BID ADDENDUM

PROJECT NUMBER	PROJECT TITLE		
23-02258	Queens Elevators – Watson Hall		
PROJECT LOCATION / ADDRESS		DATE ISSUED	ADDENDUM #
Watson Hall, 49 Bader Lane, Kingston ON		April 29, 2026	04

Architectural Addendum No. 4

Queen's Elevator Project – John Watson Hall Kingston, Ontario

3 ELEVATOR LOBBY - BASEMENT - NORTH
1:25

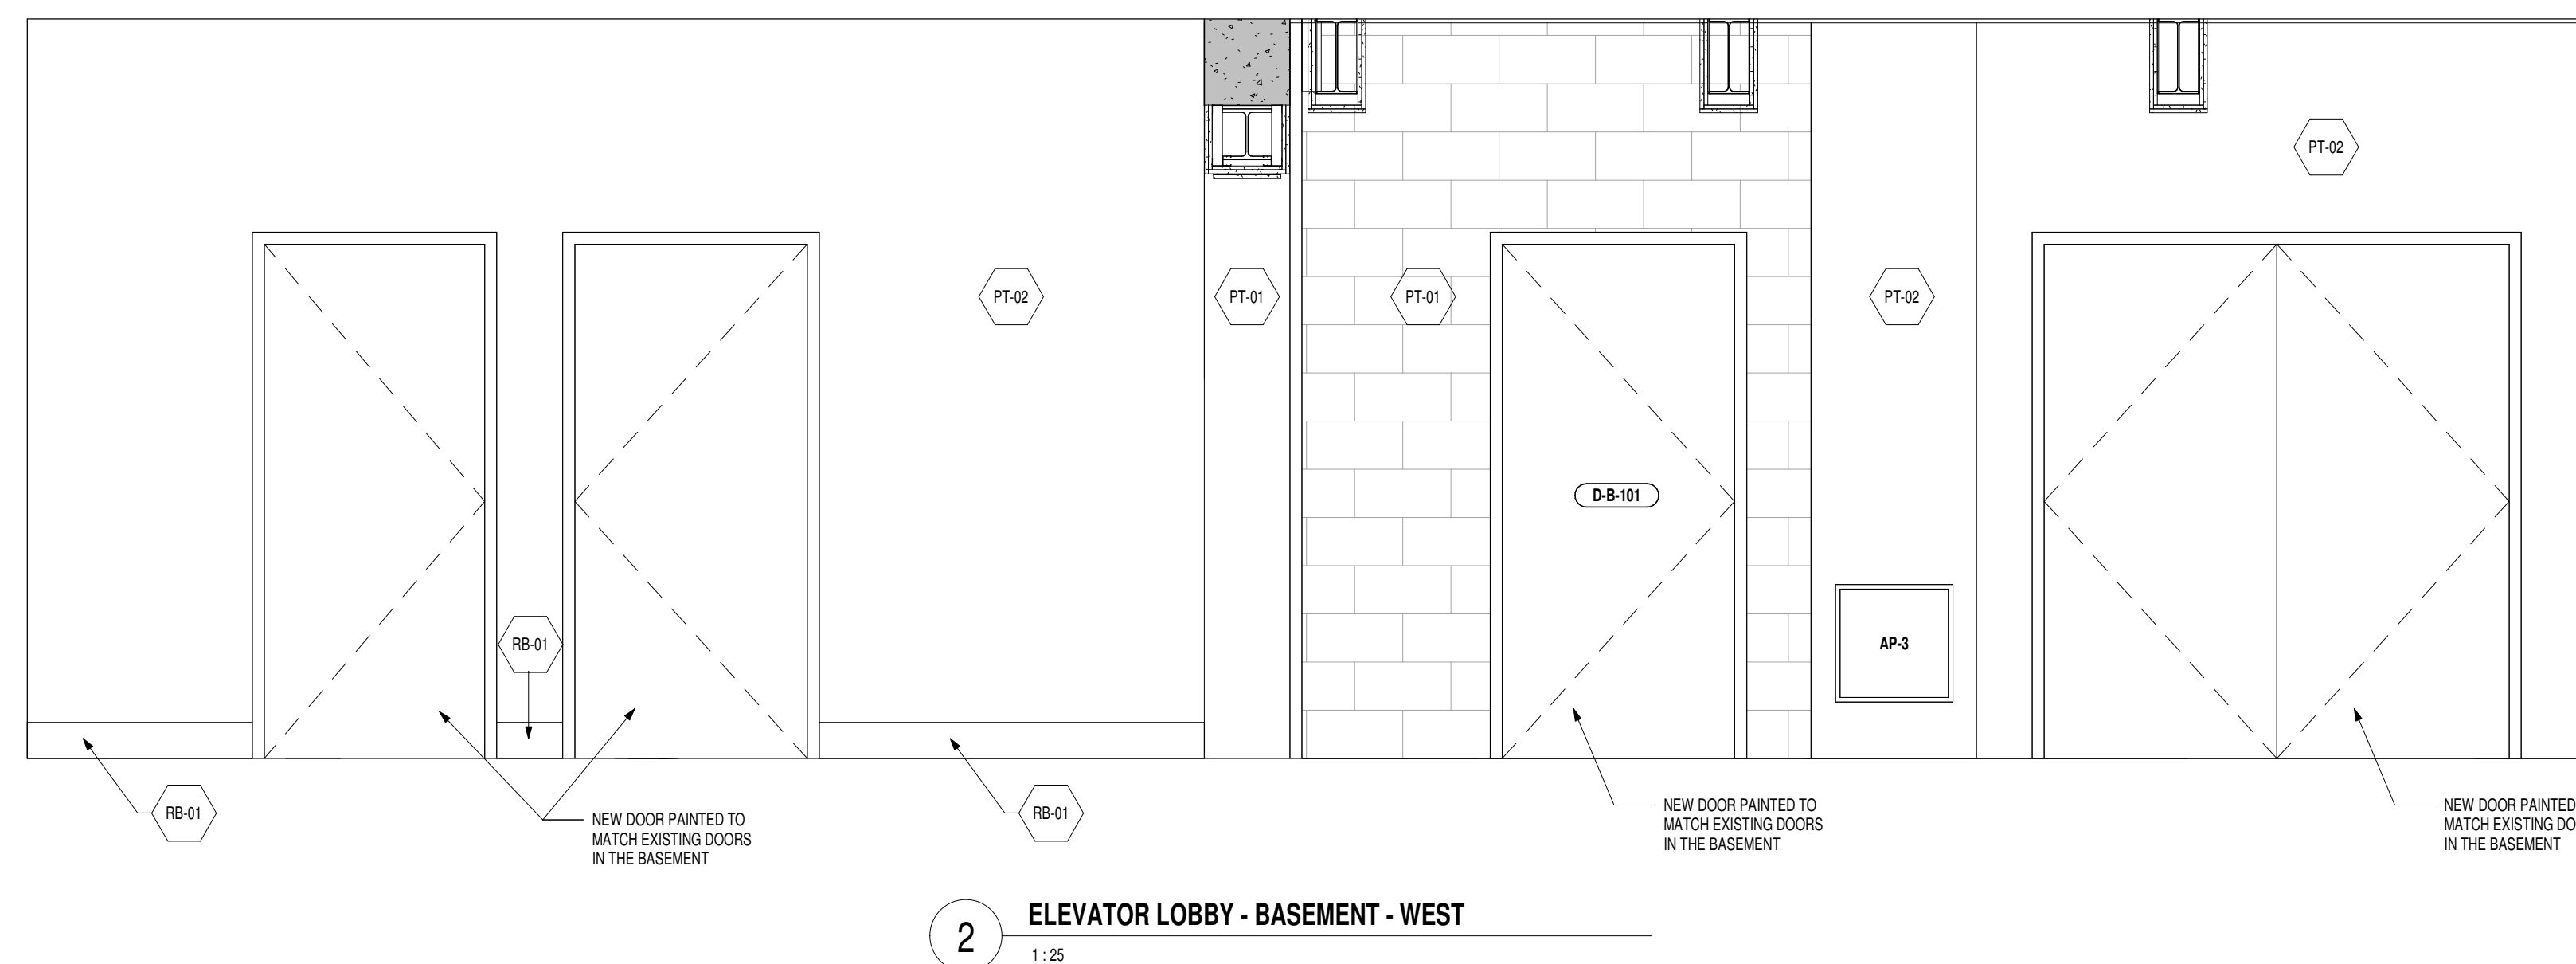
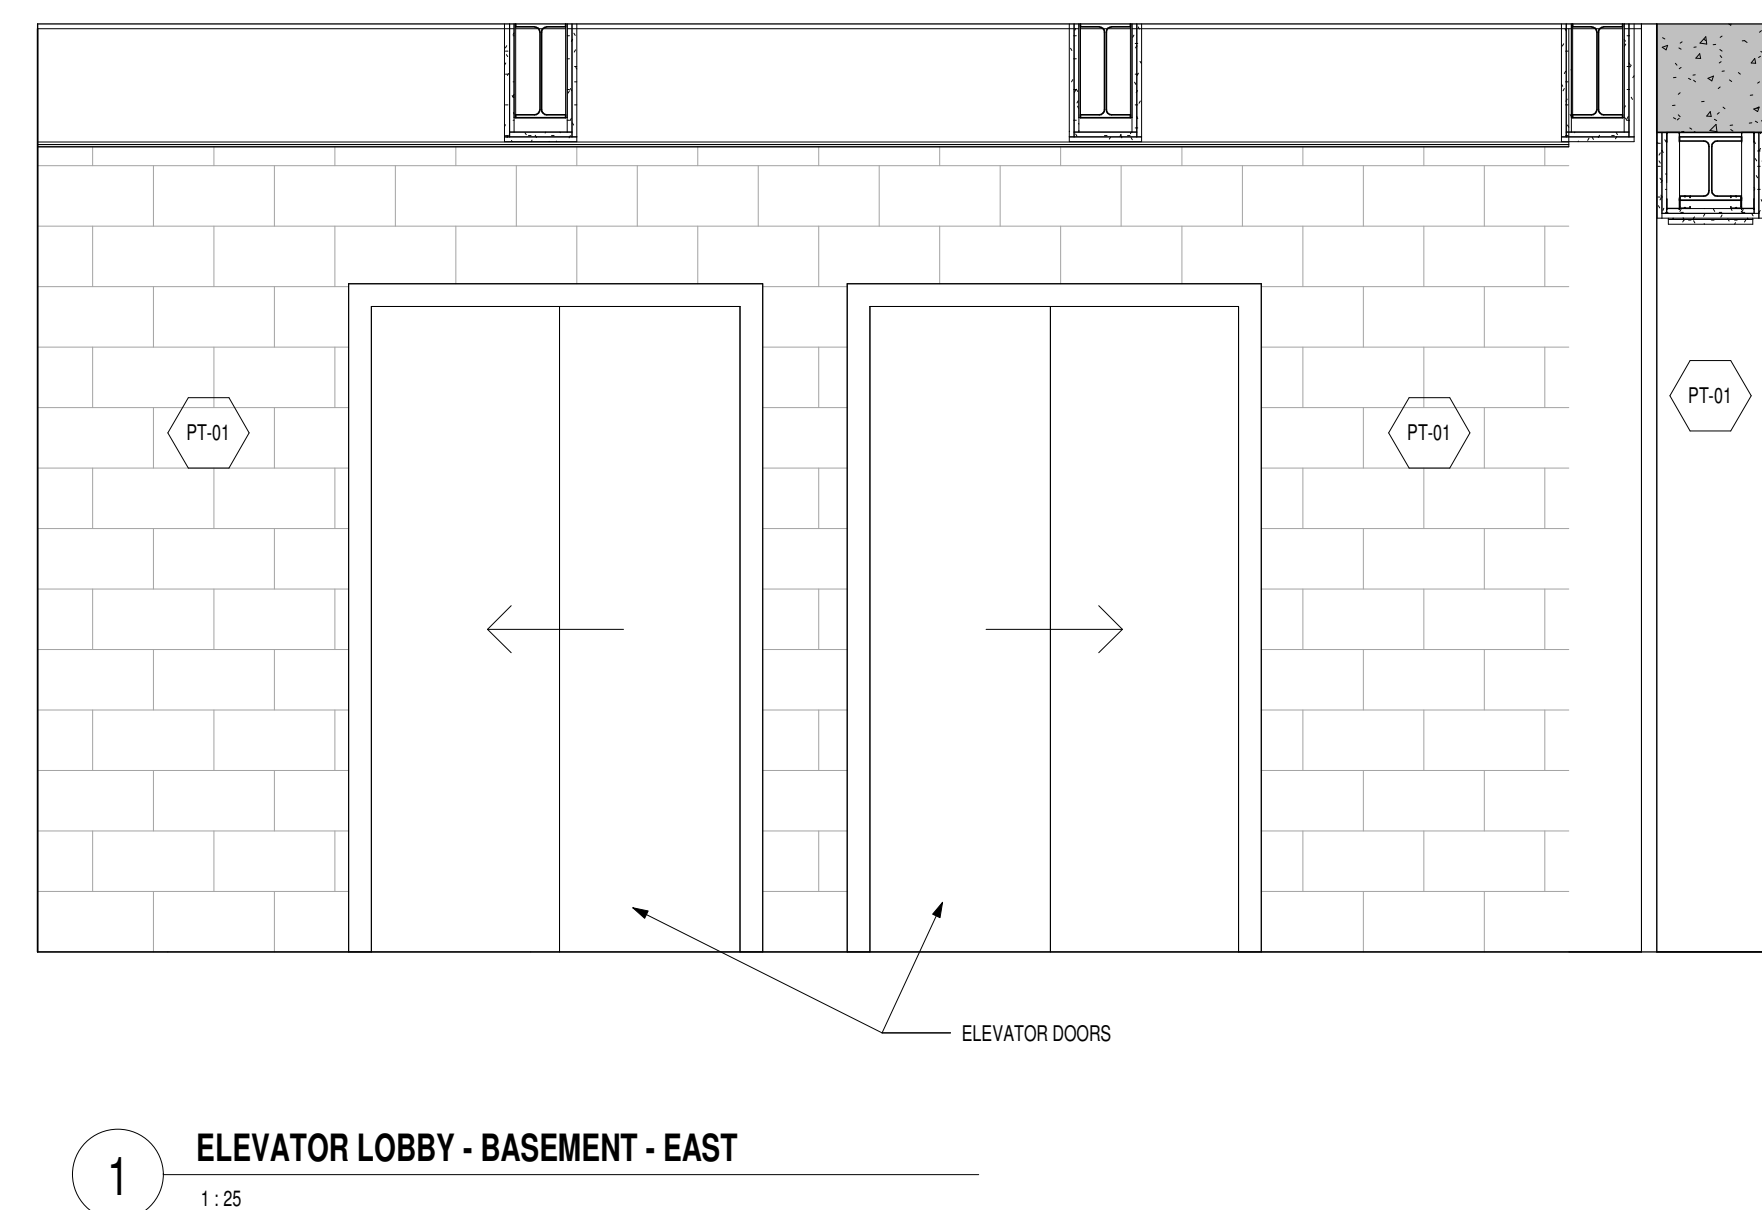
A.1 Update RB-01 and RB-02 notes to clarify the basic of design products and finishes in A7.40.

Answer: Basis of design products and finishes are added to RB-01 and Rb-02 notes. Refer to attached A7.40.
